U.S. NUCLEAR WASTE TECHNICAL
REVIEW BOARD

Report to
The U.S. Congress
And
The Secretary of Energy

January to December 1999

Figure 1-2. Cross Section of 21-PWR Spent-Fuel Waste Package

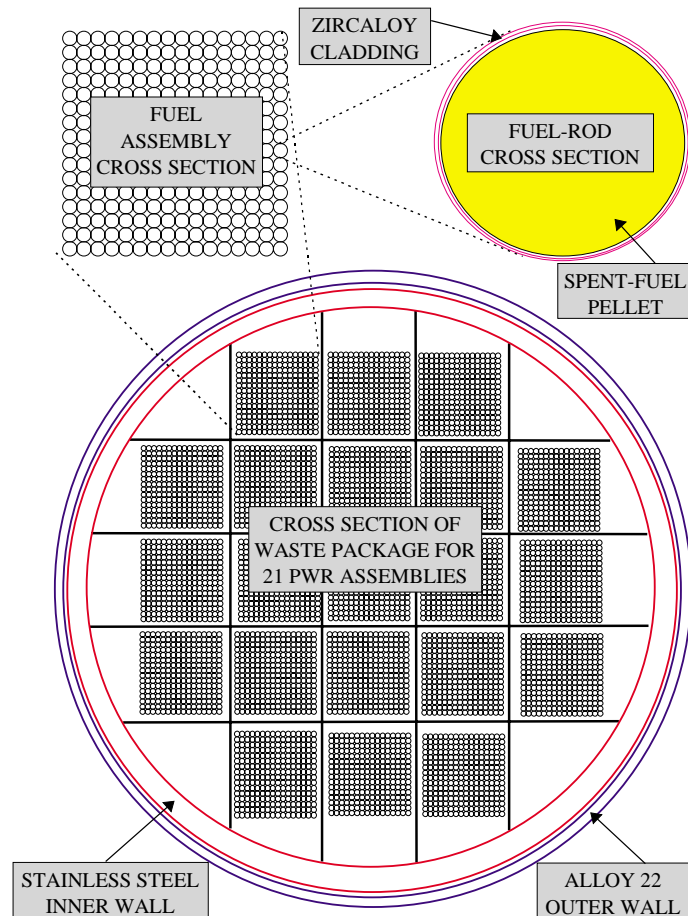
Although the exterior dimensions are almost the same, there are major differences between the LADS waste package design and the VA waste package design. The VA waste package design also is a dual-wall cylinder, but its outer wall is 100-mm-thick carbon steel and its inner wall is 20-mm-thick Alloy 22. (Eliminating the carbon steel eliminates most concerns about uncertainties caused by "oxide-wedging." In the VA design, when oxidation of the carbon steel penetrates the outer wall of the waste package, further oxidation of the steel along the crevice between the inner and outer walls conceivably could result in wedging forces large enough to cause failure of the inner wall.)

The proposed method for constructing the VA waste package was to shrink-fit the inner and outer walls to obtain a tight fit. To prevent the tensile stresses on the outer wall that shrinkfitting could cause, the LADS study design would not use shrinkfitting; thus, there would be a very small gap between the waste package's inner and outer walls.

For these reasons, and others, according to the LADS report, the LADS study waste package design would have a longer life than the VA waste package design (CRWMS 1999), even though both waste package layers were credited with improving waste package performance in the VA, but only the Alloy 22 layer was credited in the LADS study.

Figure 1-3. Cross Section of EBS and Waste Package

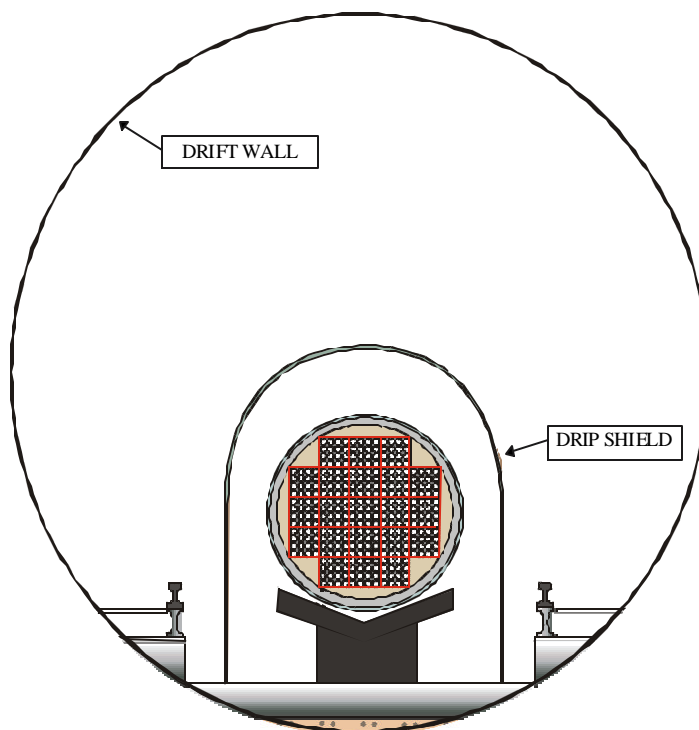
The LADS study repository design depends on the assumptions that waste packages can be placed as close as 100 mm apart and that blending will be used to ensure that the peak waste package heat output at time of emplacement would be no greater than 11.8 kilowatts (kW). Ground support for the LADS repository design consists of carbon-steel ribs or rock bolts.

The LADS study repository design represents a major departure from the VA repository design in many respects. The most significant departure is the use of ventilation in the LADS study design, as opposed to the essentially nonexistent ventilation in the VA design. Ventilating each emplacement drift with 10-15 m³ of air per second would keep drift-wall temperatures below 70°C during the preclosure period and would decrease postclosure drift-wall temperatures substantially in comparison
